**TOWN OF WINTER PARK
PLANNING COMMISSION
Tuesday, August 13, 2024 8:00 AM**

TO Planning Commission
FROM James Shockey, Community Development Director
DATE August 13, 2024
RE Minor Site Plan – Lot 1, Block 3, Roam Filing No. 1, 146 Exploration Trail (PLN24-059)

TO Planning Commission
FROM Brian P Kelly, Senior Planner
THROUGH James Shockey, AICP, Community Development Director
DATE August 08, 2024
RE Minor Site Plan – 285 Bridger Trail - Lot 8 Bridger’s Cache (PLN24-062)

A1.0
 PLOT / ROOF PLAN

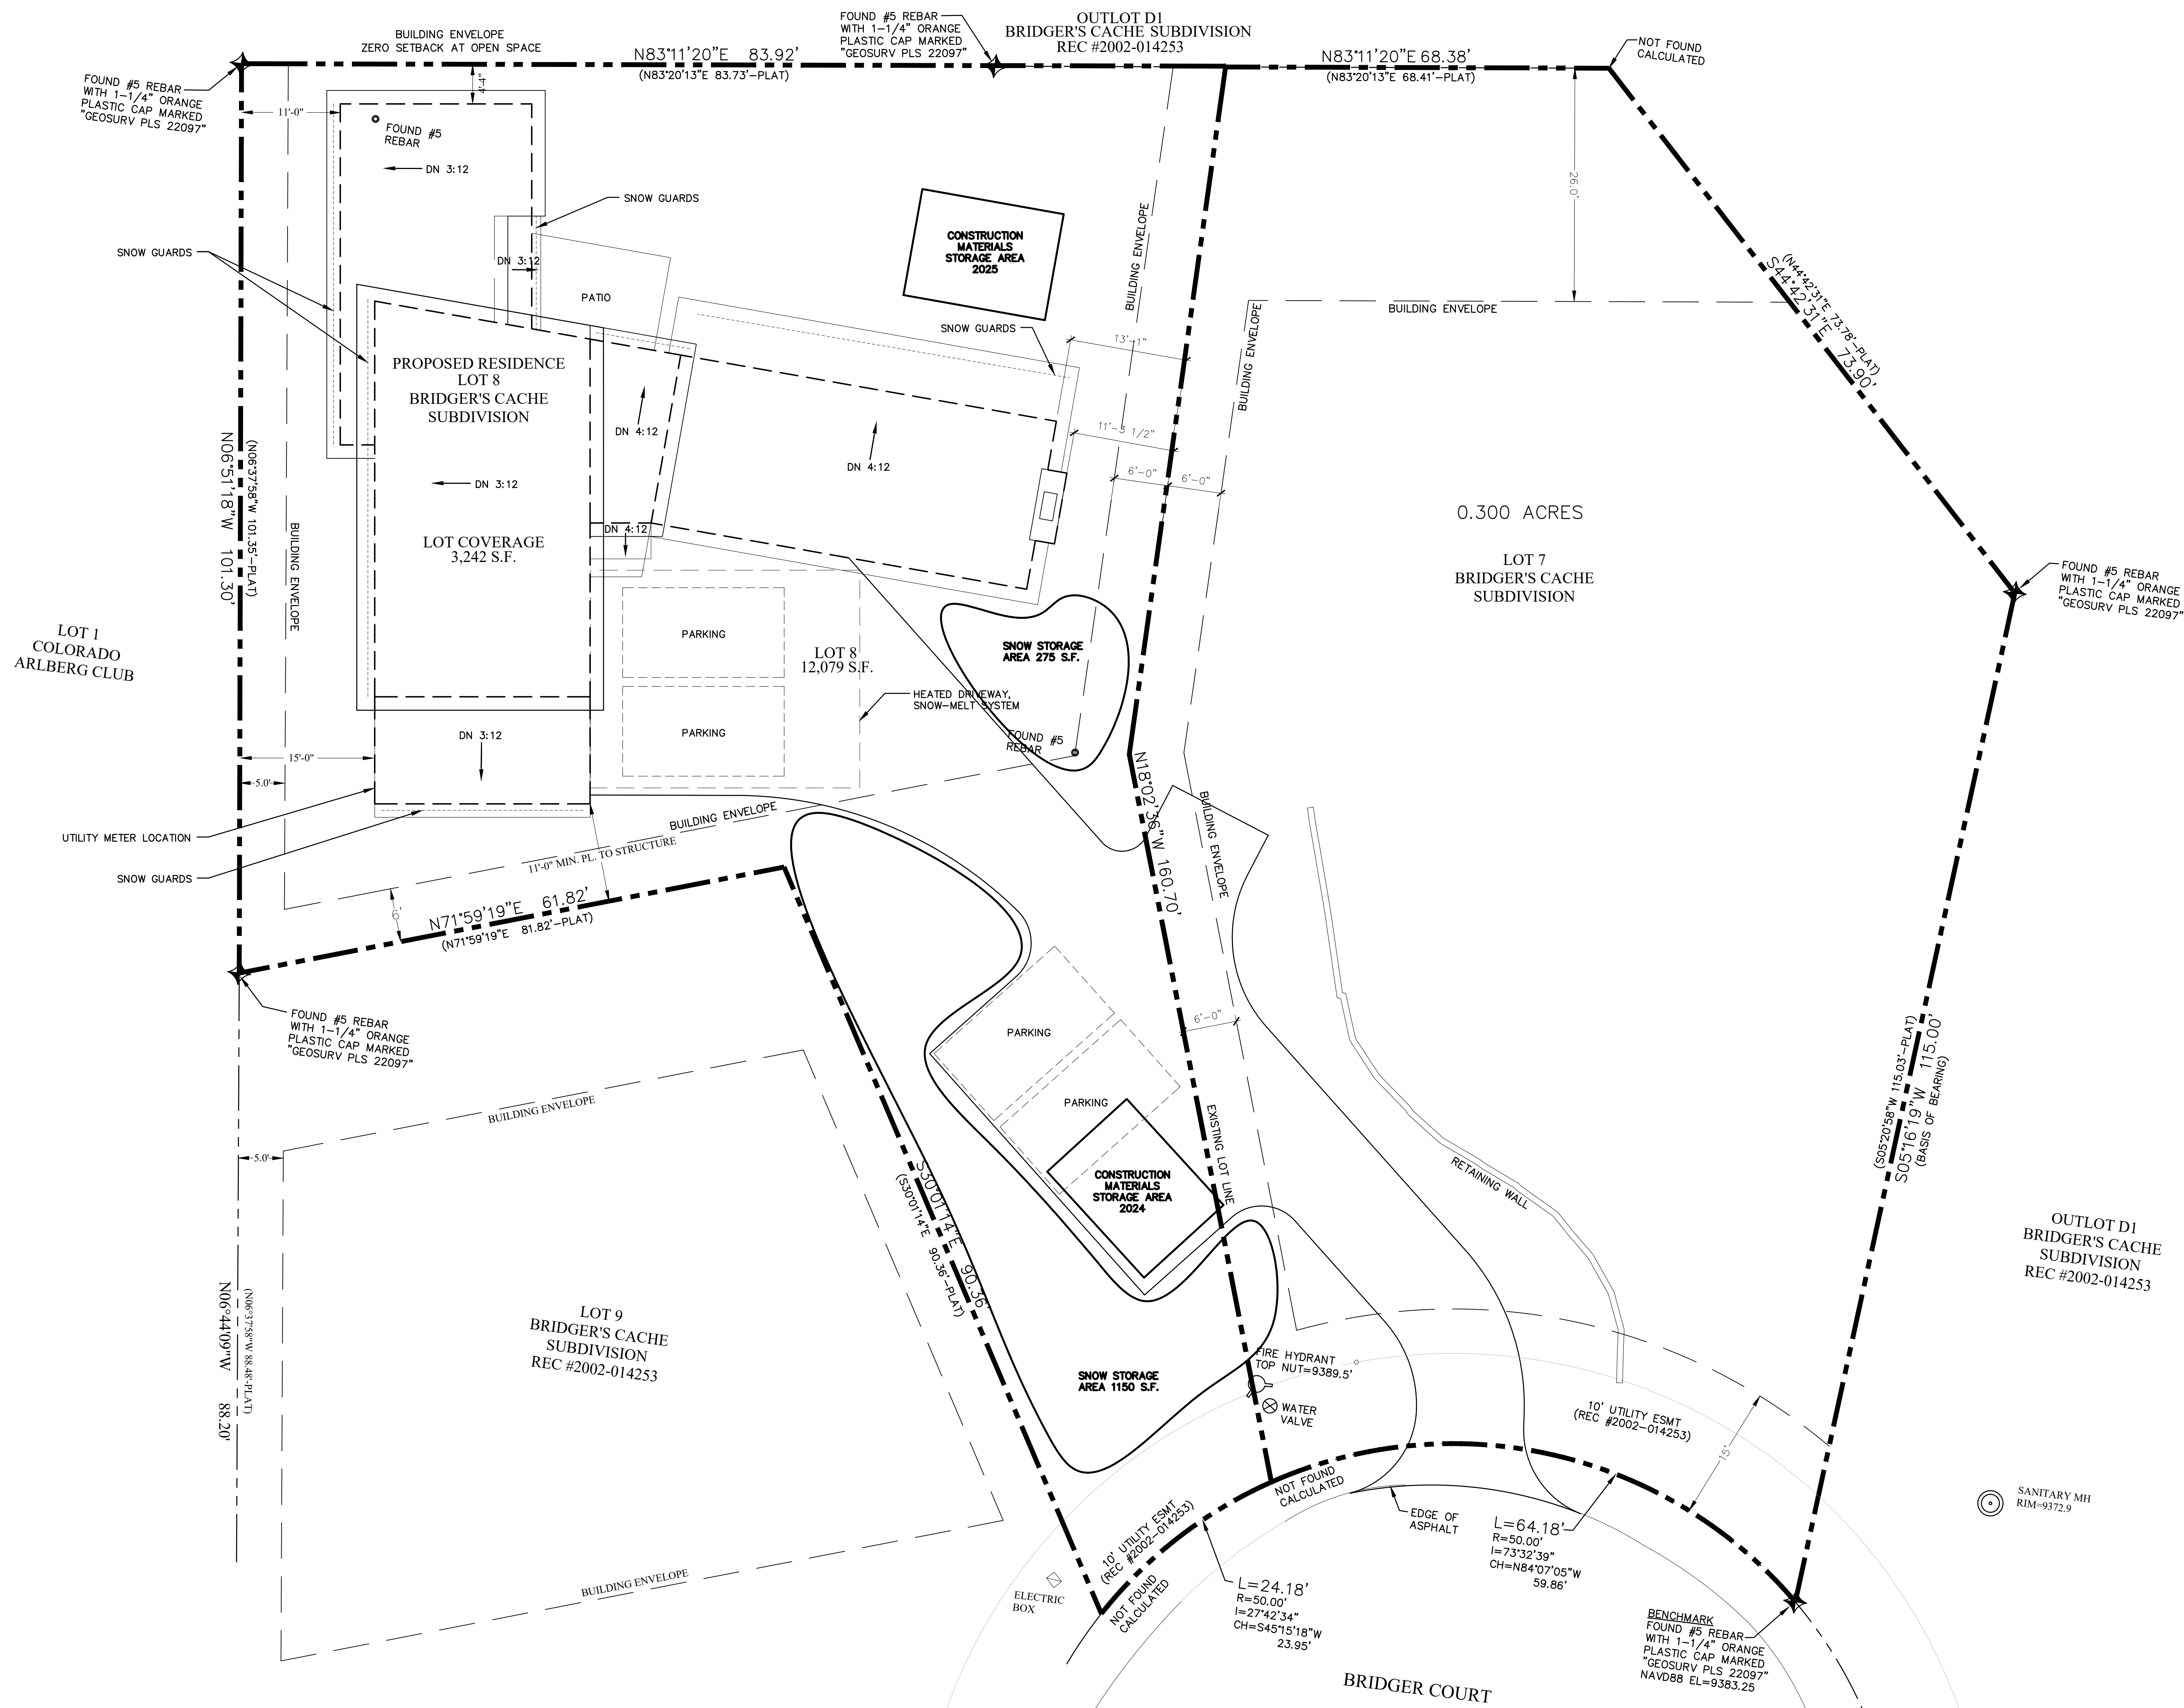
Unsatisfactory. The submitted site plan is missing setback distances to the existing and proposed retaining walls. The location of trash receptacles and refuse containers must be identified; permanent trash enclosures must be screened from view and comply with Sec. 3-I-6.

Unsatisfactory. The proposed dwelling utilizes greater than 40 percent building coverage, and the architectural plans (53%) and civil plans (47%) are inconsistent in the calculation of proposed building coverage.

- Applicant must update the site plan to indicate locations of Trash Enclosures (if applicable).
- Applicant must update the site plan to include setback distances of existing and proposed retaining walls to a point on the property line.
- NOTE: The Temporary Construction Material Storage Area 2025 appears to be in an area that will be inaccessible upon completion of the retaining walls and rip-rap swale.

- Applicant will resubmit prior to Building Permit a revised site plan demonstrating a reduction
